3.4 Instrumentation and Control

STD DEP T1 3.4-1 (Figure 3.4a, Figure 3.4b, Figure 3.4c)

Figure 3.4a Safety System Logic and Control (SSLC) Control Interface Diagram

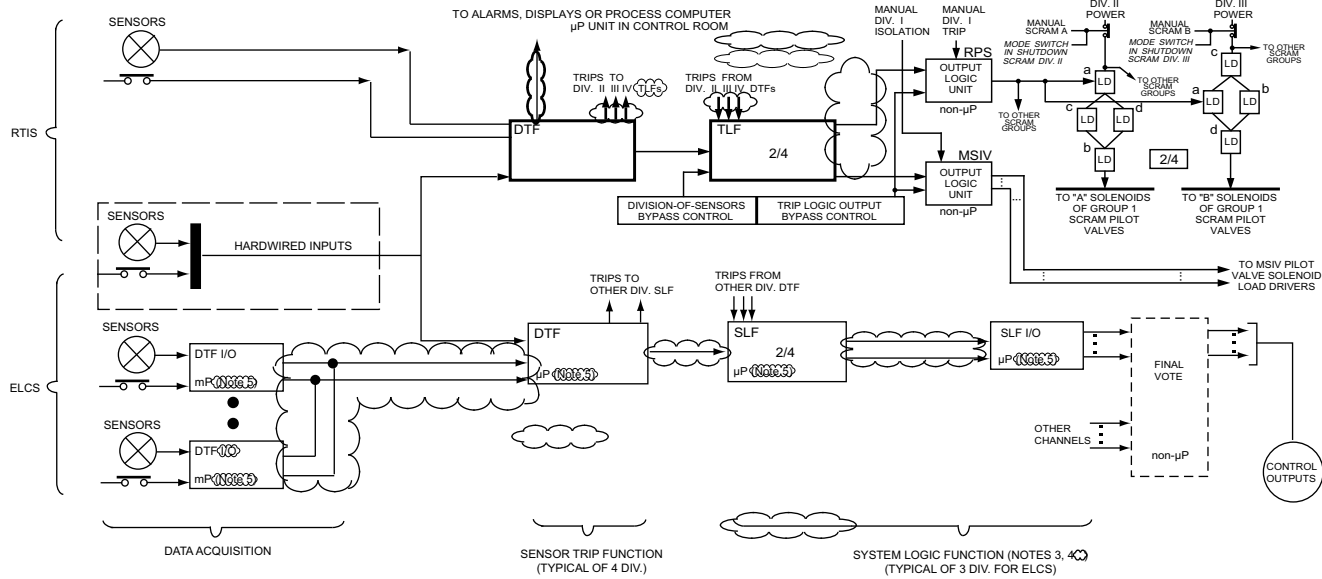
safety-related portions of the Neutron Monitoring System (NMS), the Containment Atmospheric Monitoring System (CAMS) and the radiation monitoring systems. The relationship between SSLC and systems for plant protection is shown in Figure 3.4a.

Figure 3.4b Safety System Logic & Control Block Diagram

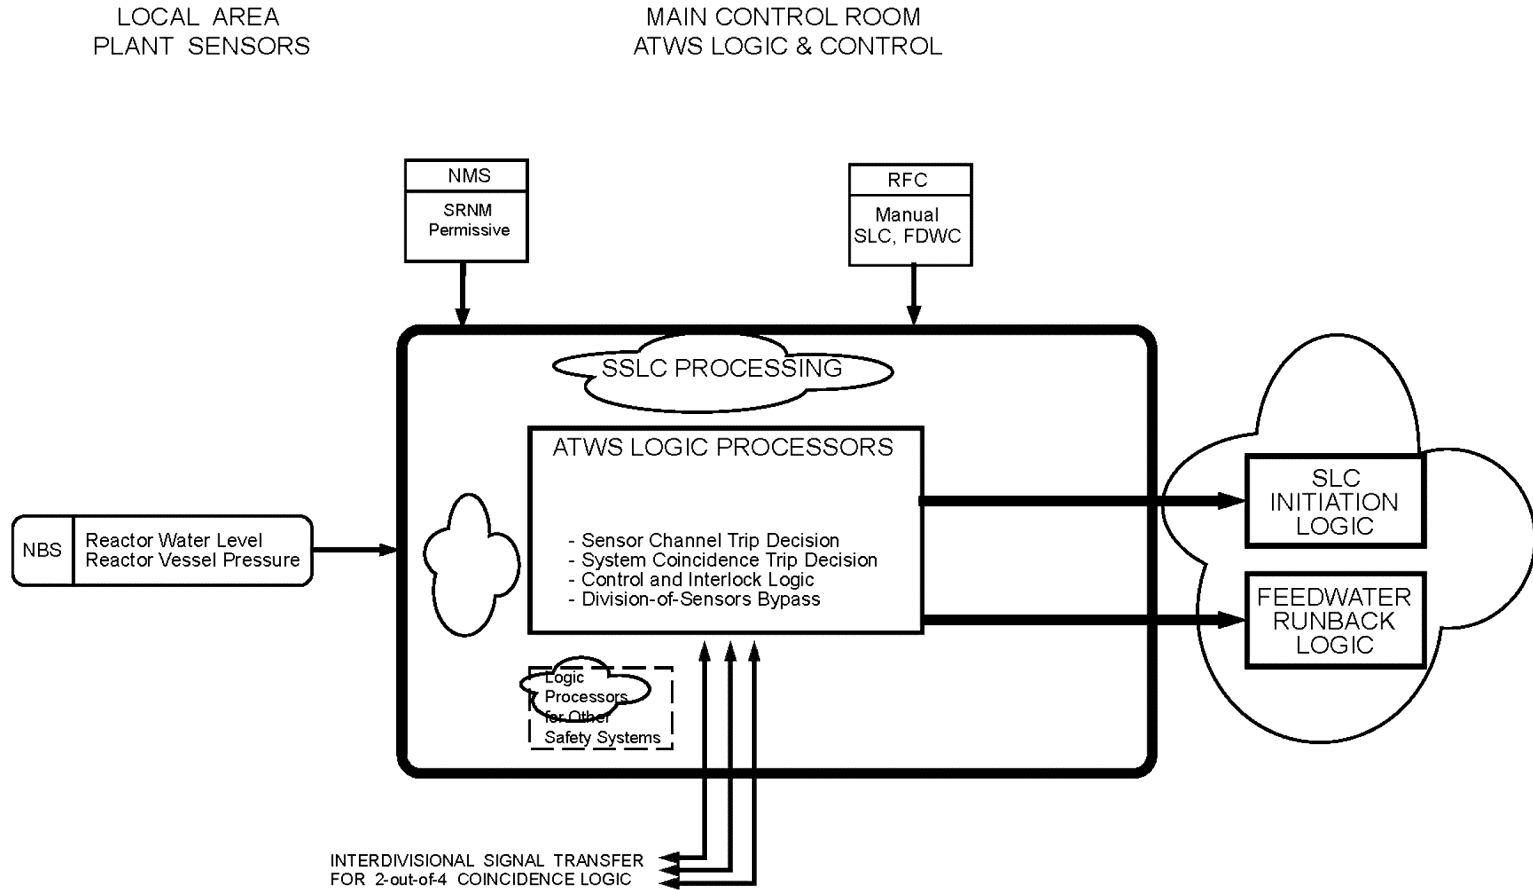
~~The basic hardware functional configuration for one division of SSLC is shown in Figure 3.4b. Each division runs independently (i.e., asynchronously) with respect to the other divisions. The following steps describe the processing sequence and associated function descriptions for incoming sensor signals and outgoing control signals. These steps are performed simultaneously and independently in each of the four divisions:~~

- ALL SOLID LINE CONNECTIONS NOT EXPLICITLY IDENTIFIED CAN BE EITHER HARD WIRED OR FIBER OPTIC.
- SAFETY SYSTEM LOGIC FUNCTION (SLF) FOR ECCS FUNCTIONS IS IMPLEMENTED WITH REDUNDANT CHANNELS WITH A MINIMUM 2/2 VOTE OF THE OUTPUT SIGNALS TO PREVENT INADVERTENT COOLANT INJECTION OR DEPRESSURIZATION DUE TO SINGLE SLF ELECTRONICS FAILURE. THE OUTPUT VOTE MAY BE ACCOMPLISHED EITHER BY DIRECT VOTE OF SLF OUTPUT SIGNALS OR BY A SYSTEM VOTE WHERE BOTH VALVE AND PUMP ACTUATION IS REQUIRED TO INITIATE SYSTEM ACTION. BYPASS OF A FAILED SLF CHANNEL MAY BE PROVIDED AS LONG AS THE REMAINING OPERATIONAL CHANNELS PROVIDE A MINIMUM OF TWO SLF CHANNELS FOR ECCS FUNCTIONS.**

- SAFETY SYSTEM LOGIC FUNCTION (SLF) FOR SOME ISOLATION AND SUPPORTING ESF FUNCTIONS MAY BE IMPLEMENTED WITH REDUNDANT CHANNELS WITH A NORMAL MINIMUM 2/2 VOTE OF THE OUTPUT SIGNALS WHERE INADVERTENT ACTUATION OF THE FUNCTION MIGHT REQUIRE UNREASONABLY SHORT REPAIR TIMES TO ELIMINATE OPERATIONAL IMPACT. FOR THESE FUNCTIONS, OPERATIONAL CONTROLLED BYPASS TO ALLOW OPERATION WITH A FINAL 1/1 VOTE IS PERMITTED.**
